Addendum

Reconstruction at
Mahopac High School
Mahopac Middle School
Mahopac Falls School
Bus Garage
New Pump House

BID Addendum No. 3 to Drawings and Project Manual

February 22, 2021

1 Electrical Site Demolition Plan
1" = 30'

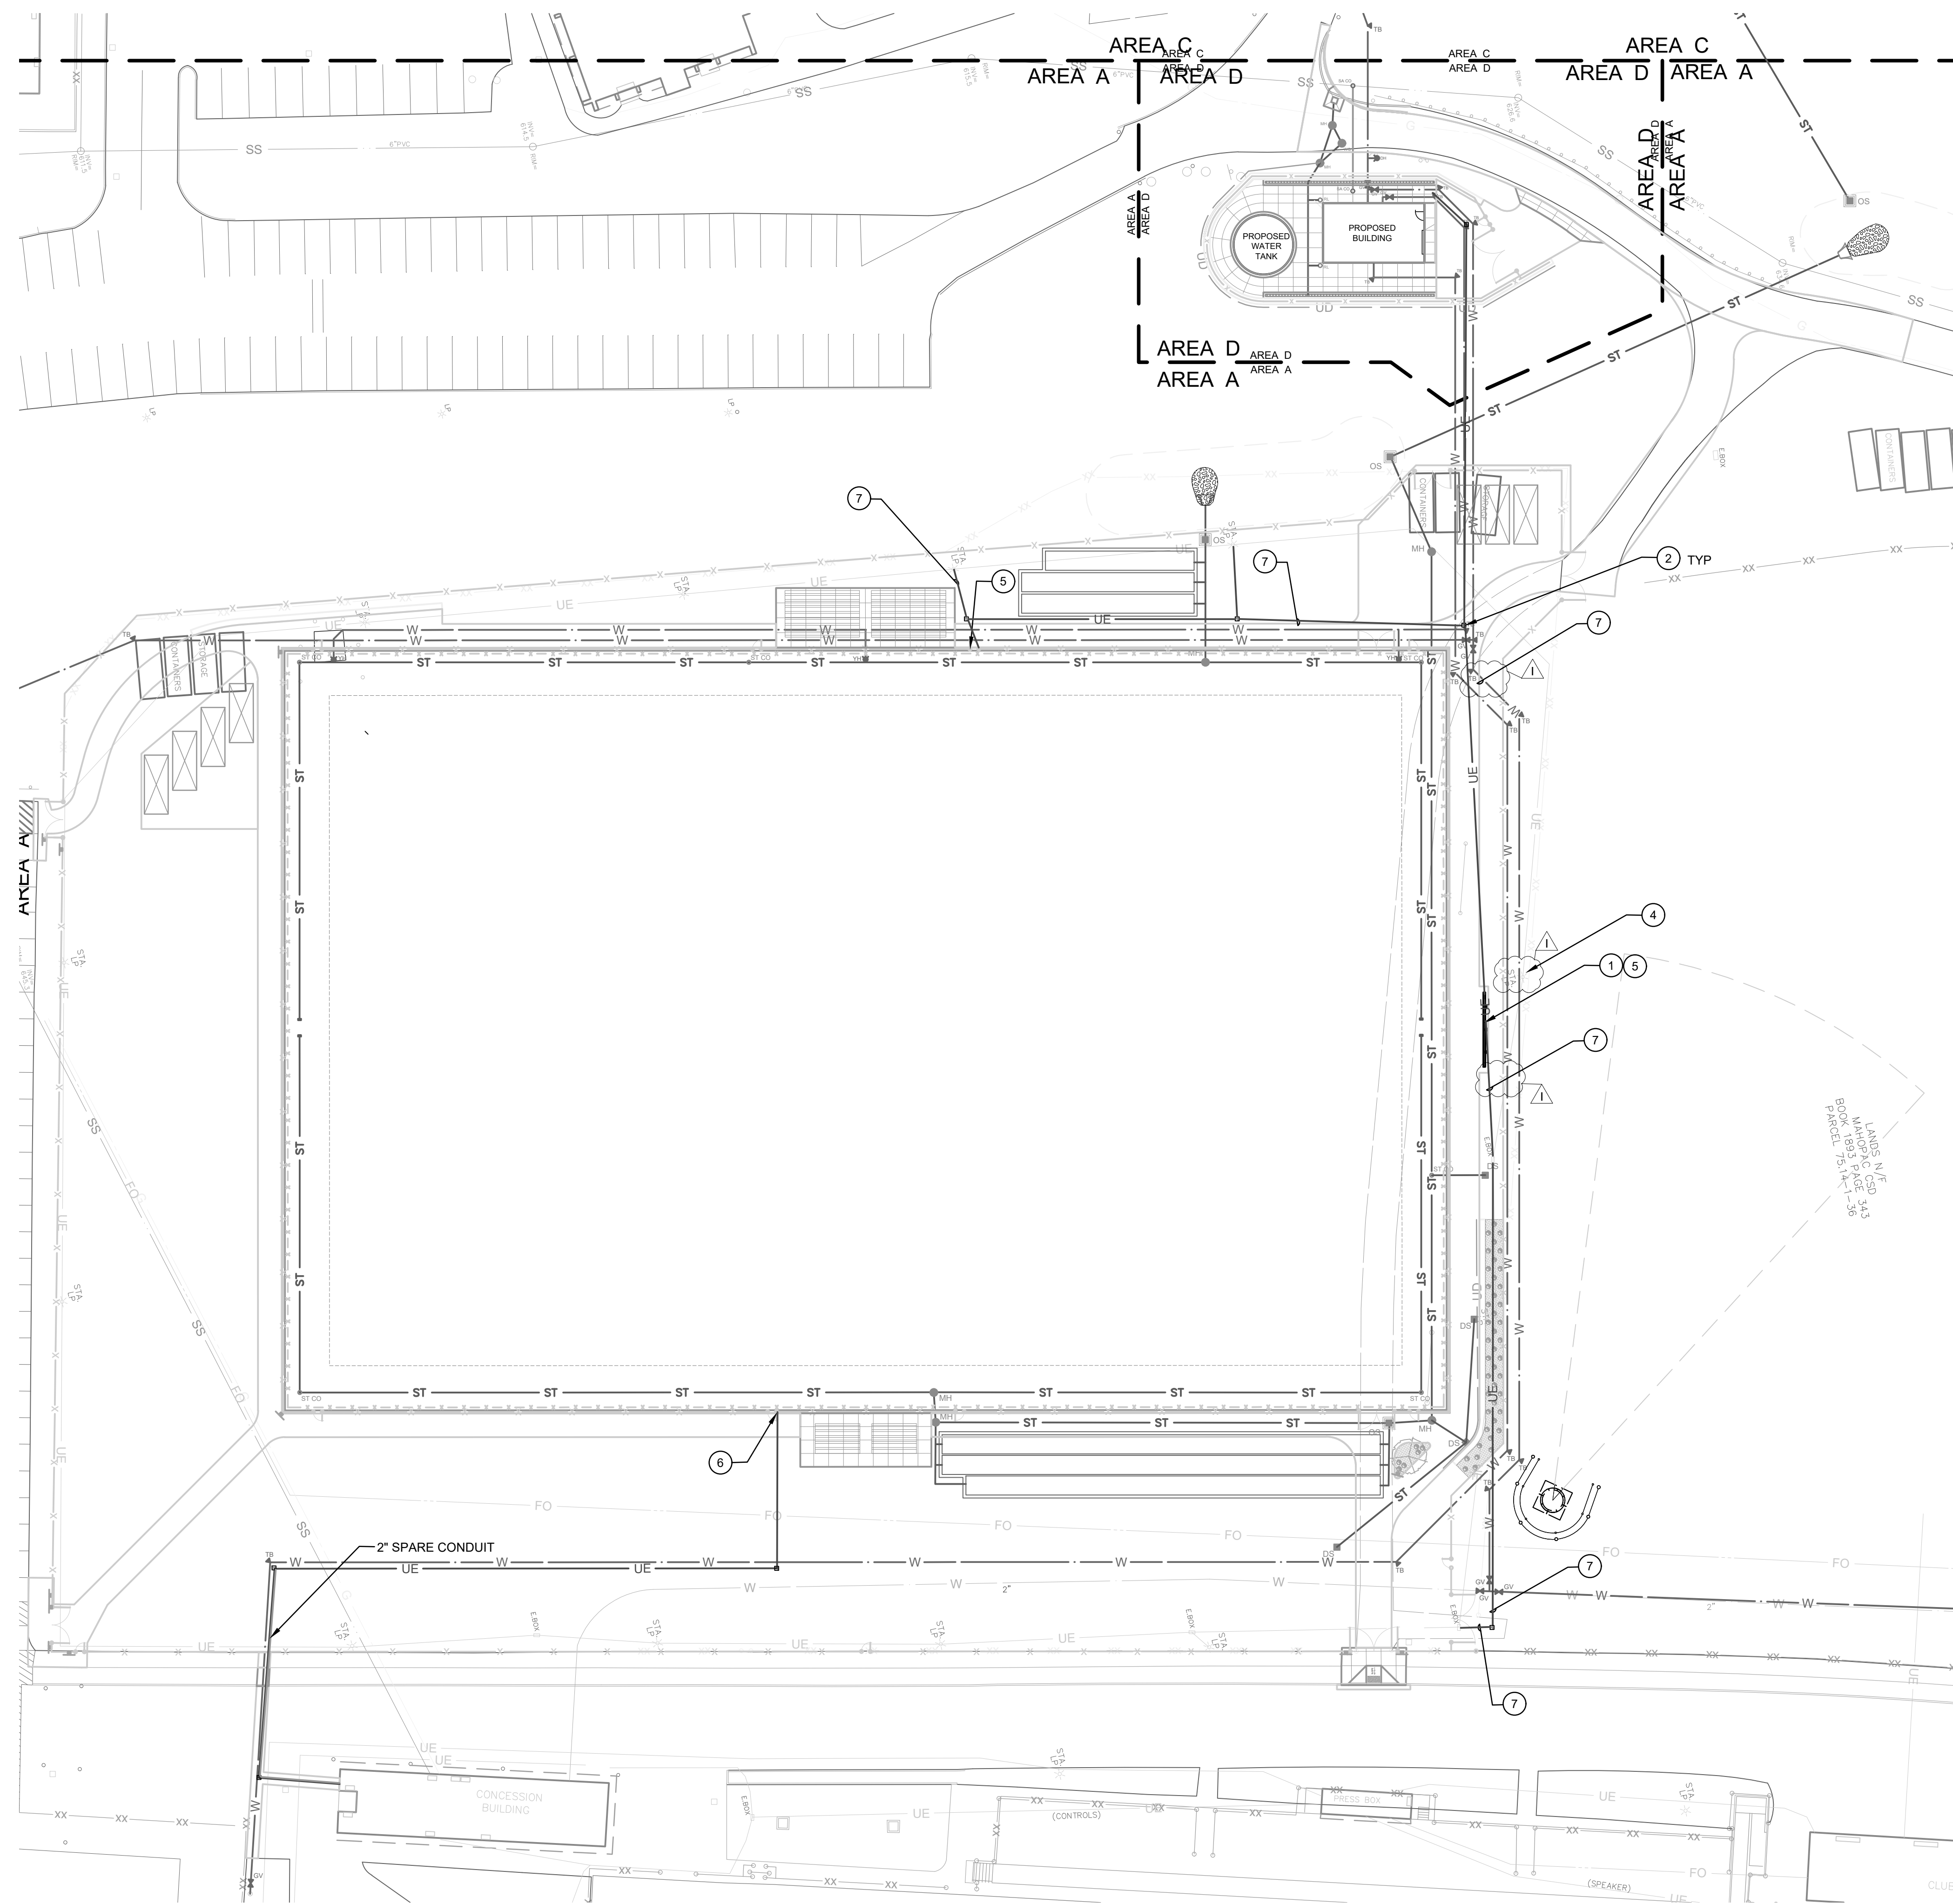
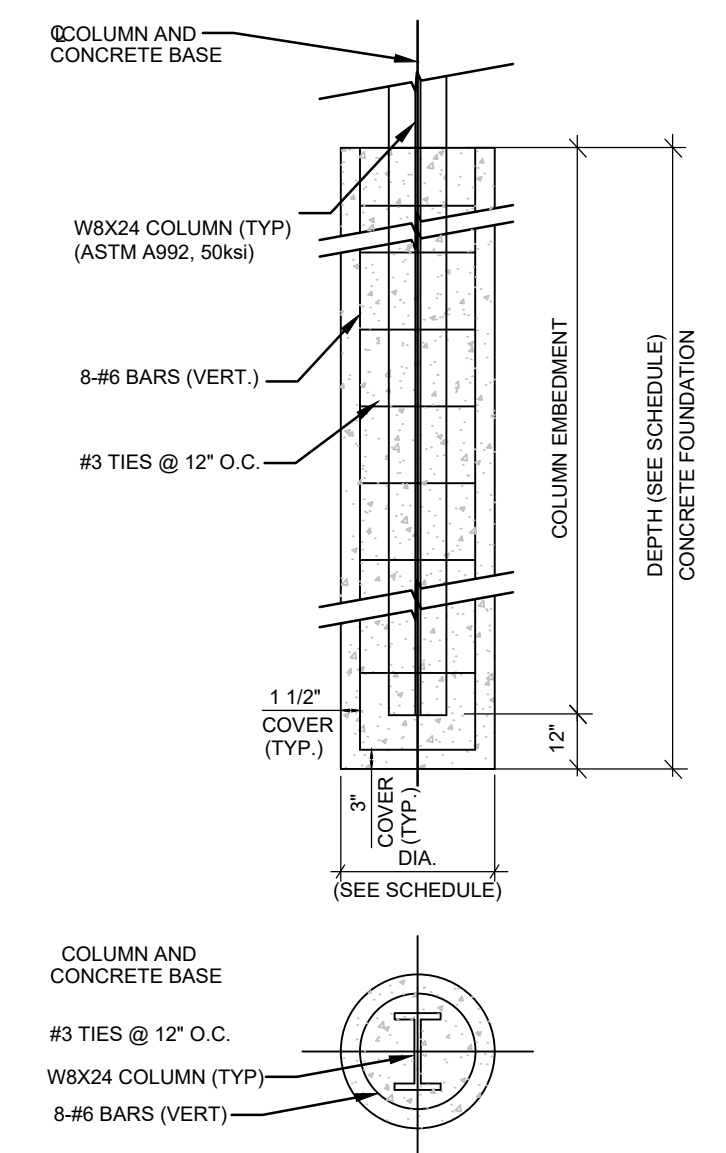
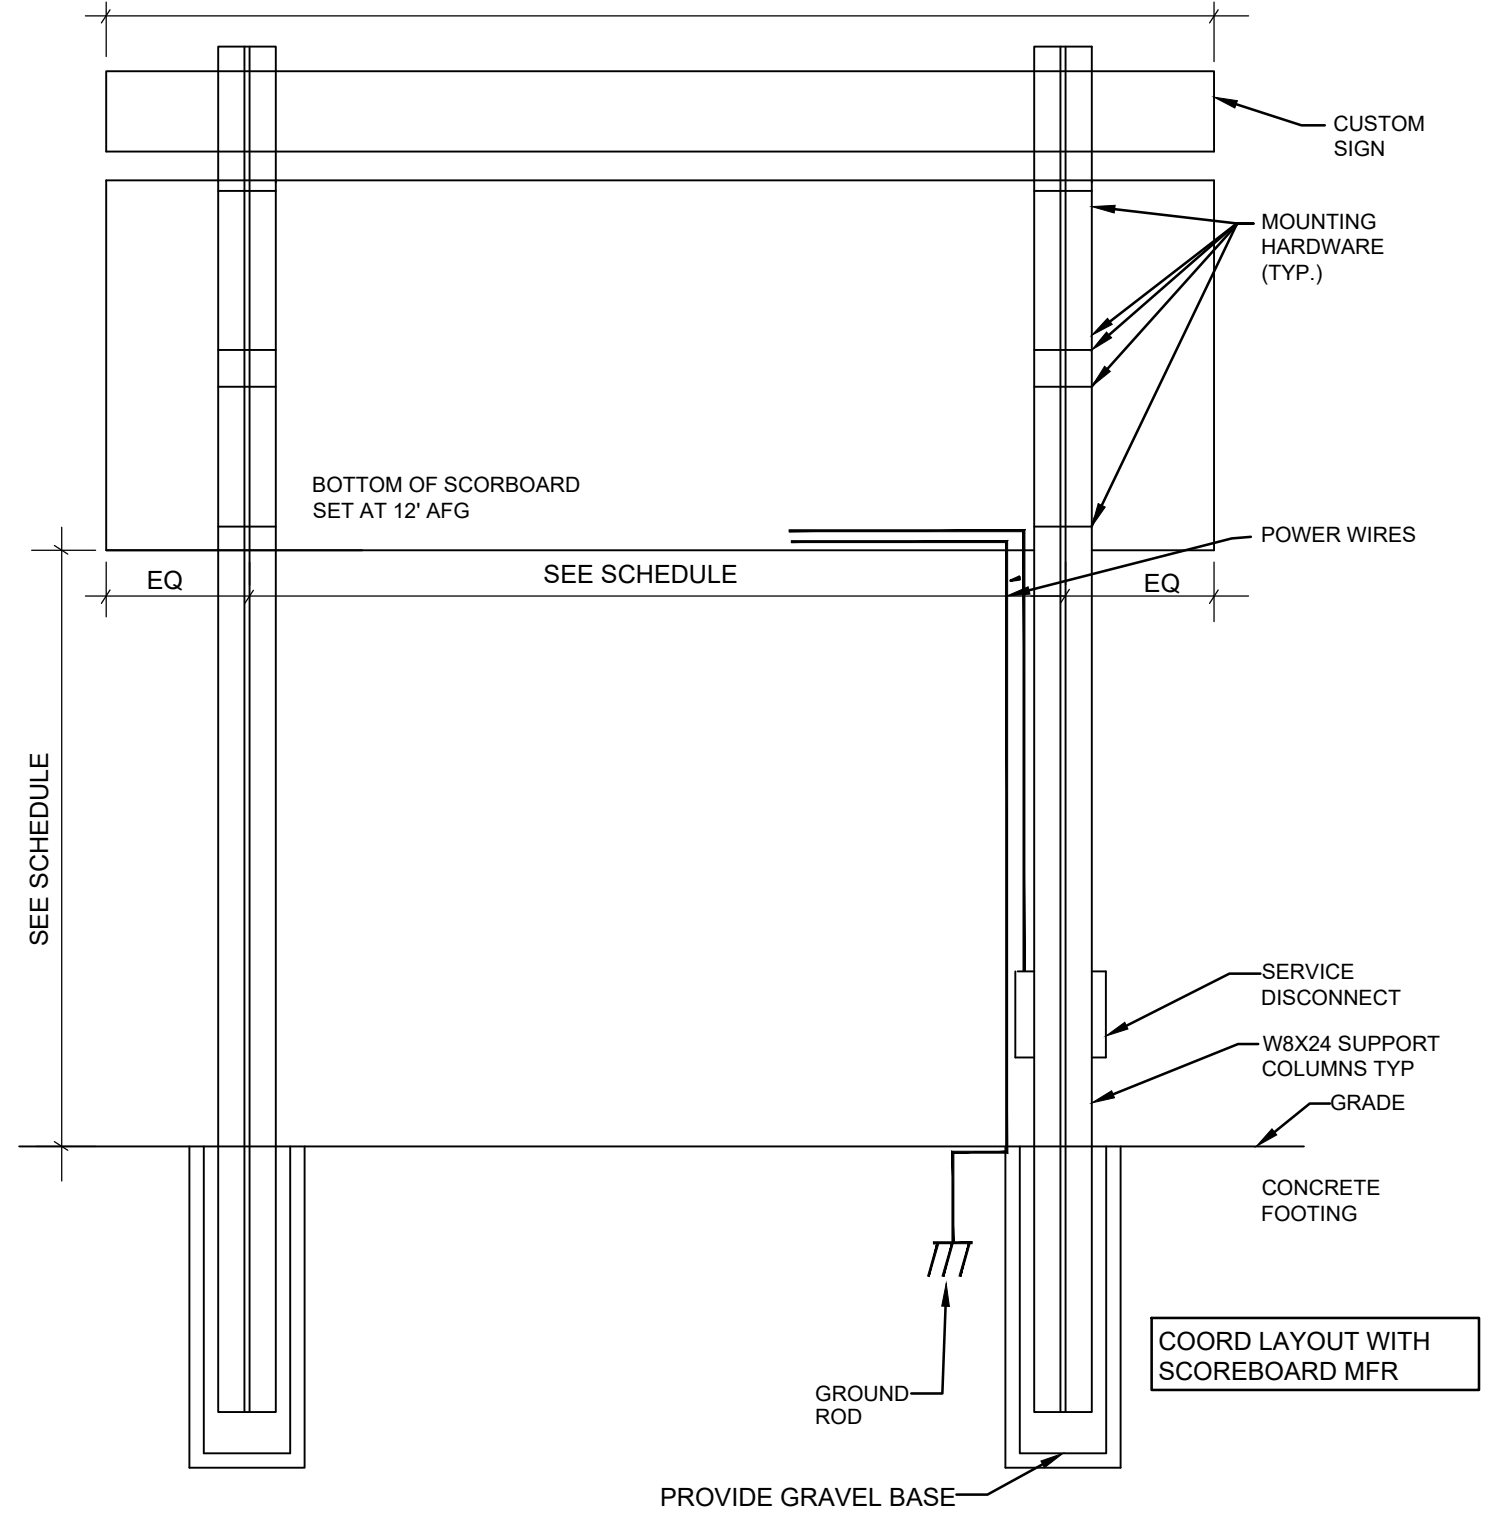
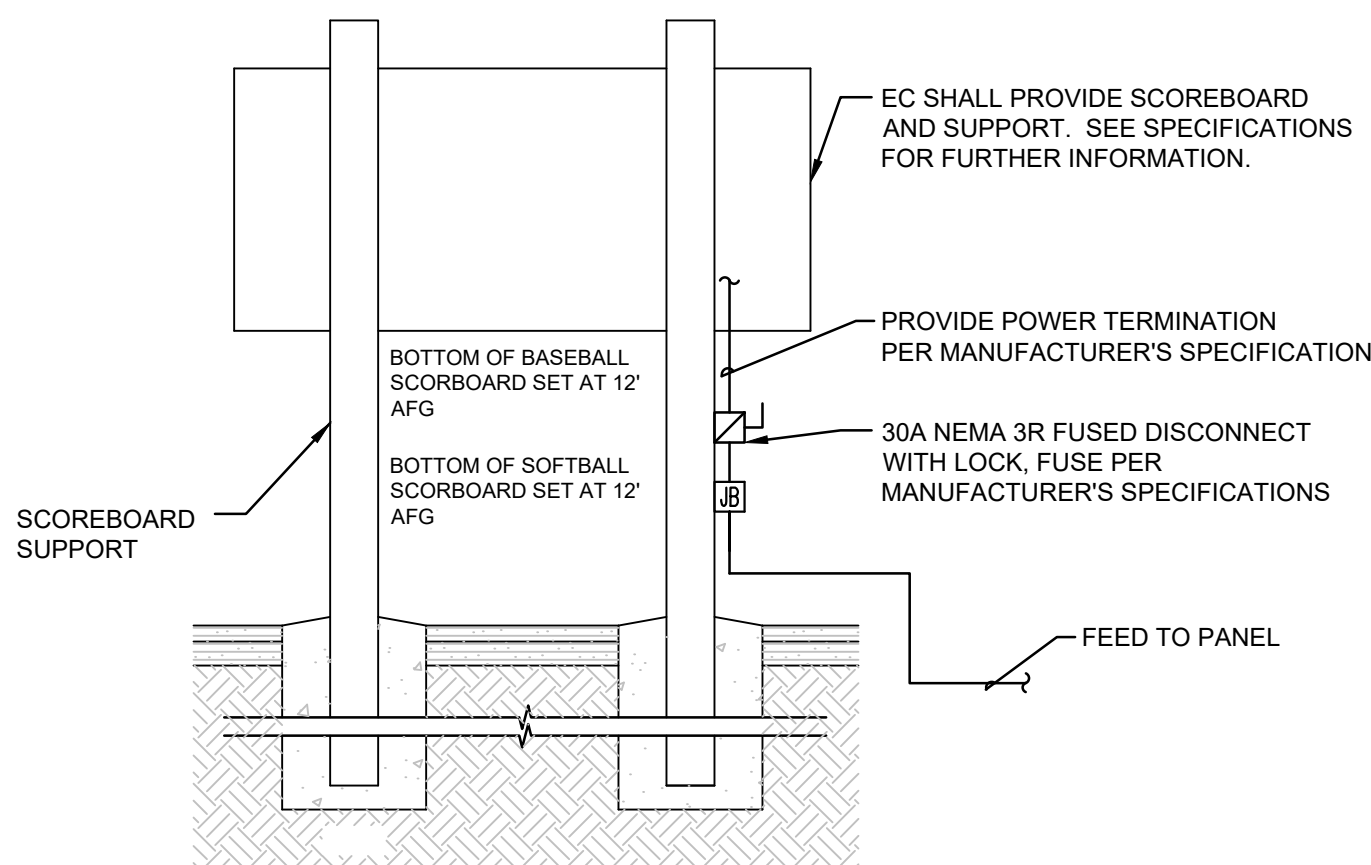
Question: (Please be specific) 1. note 1 to reroute existing feeder, where are we rerouting this to, please clarify scope of work?
